HOGAN – GUNTER SUBDIVISION

APPLICATION NUMBER 15 DATE July 2, 2009

DETAIL SITE PLAN

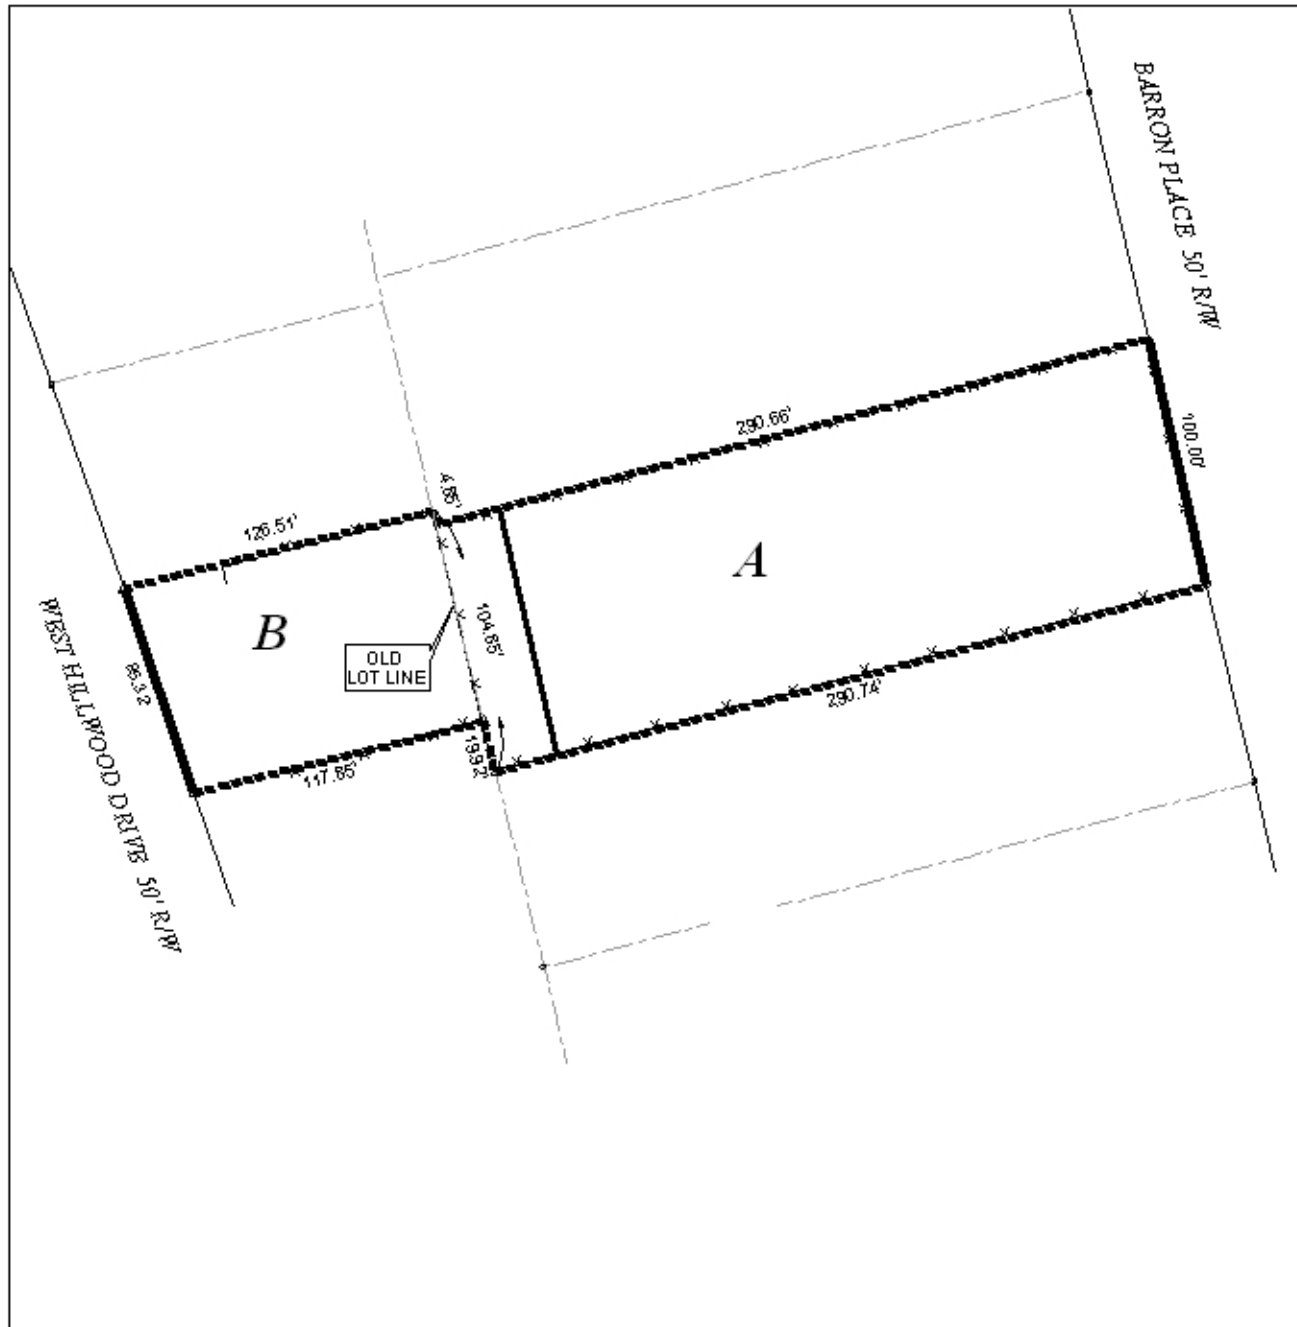
Proposed Lot A fronts Barron Place, and proposed Lot B fronts Hillwood Drive West, both with compliant 50' rights-of-way; therefore, no dedication would be required. As a means of access management, a note should be required on the final plat stating that each lot is limited to one curb cut, with the size, location, and design to be approved by Traffic Engineering and conform to AASHTO standards. The plat should be revised to illustrate the 25' minimum building setback line along both street frontages. Also, each lot should be labeled with its size in acres and square feet, or a table should be furnished on the final plat providing the same information.

The GIS database indicates an accessory structure located close to the rear property line on existing Lot 8, Block B, Barron Subdivision. Verbal discussion with the applicant's surveyor indicates this structure is actually on the half-lot parcel to the West, close to the current rear property line. The proposed 25' addition to the rear of the half-lot parcel would remedy any rear setback encroachment and allow for the applicant's planned expansion of the structure into a greenhouse. As the resultant shape of proposed Lot B would only be slightly out of character of the neighborhood, a waiver of Section V.D.1. of the Subdivision Regulations would not be out of order.

- 1) placement of a note on the final plat stating that each lot is limited to one curb cut, with the size, location, and design to be approved by Traffic Engineering and conform to AASHTO standards;
- 2) illustration of the 25' minimum building setback line along both street frontages;
- 3) labeling of each lot with its size in square feet and acres, or the furnishing of a table on the final plat providing the same information;
- 4) placement of a note on the final plat stating that development of this site must be undertaken in compliance with all local, state and Federal regulations regarding endangered, threatened or otherwise protected species; and
- 5) subject to the Engineering Comments: *(Must comply with all storm water and flood control ordinances. Any work performed in the right of way will require a right of way permit).*
